JK Knit Composite Limited (Textile & Utility Buildings)

03 July 2022

Observations

Discrepancy between as-build drawing and on-site condition

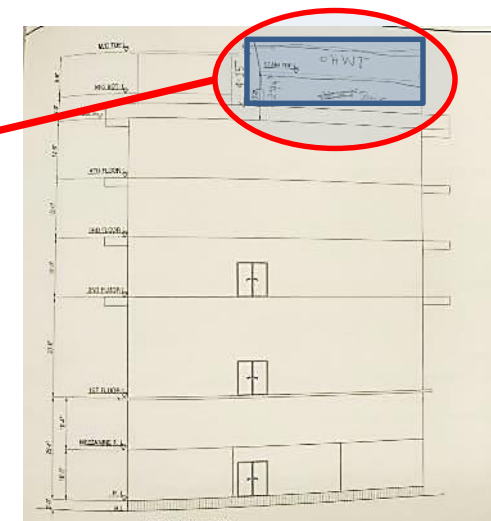
South East Staircase (OHWT not constructed)

OHWT shown in the As-built drawing

OHWT constructed over South East Staircase

No OHWT shown in the As-built drawing

Discrepancy observed in the provided drawing. Factory Engineer is required to prepare as-built drawing.

Lack of bracing at steel roof

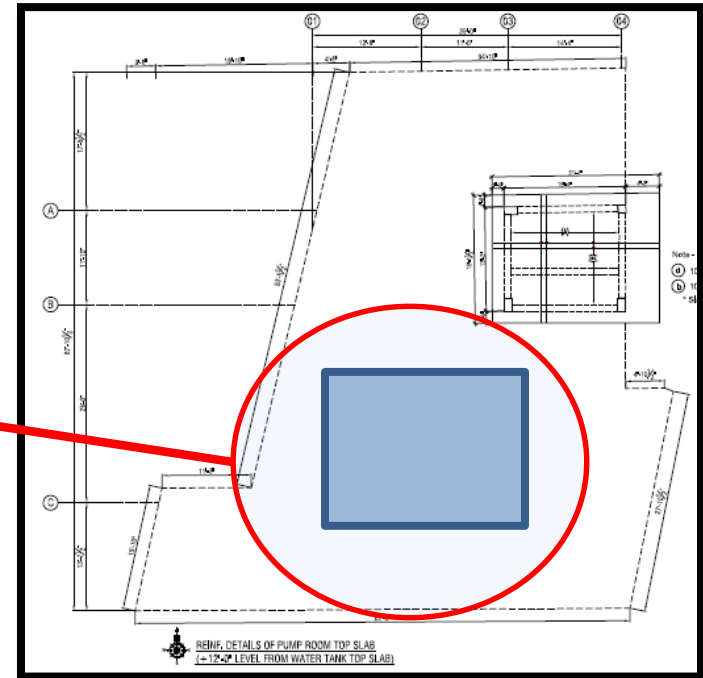
Lack of bracing at roof

The building engineer is required to check the requirement of roof bracing.

Observation: Fire Pump Room

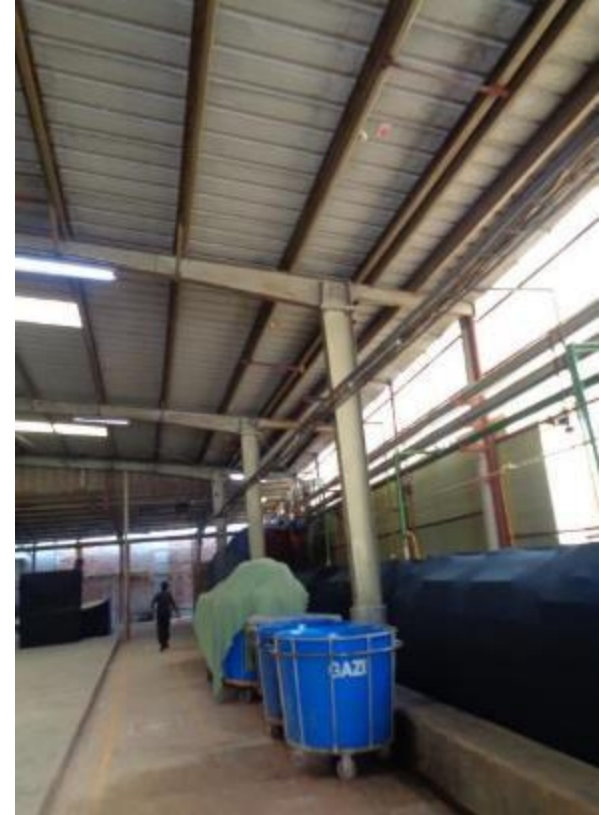
Undocumented platform on the top slab of OHWT

Undocumented rooftop slab and column on site

Rooftop slab over UGWT not shown in Drawing

The building engineer is required to update the as-built drawing and check the capacity of top slab.
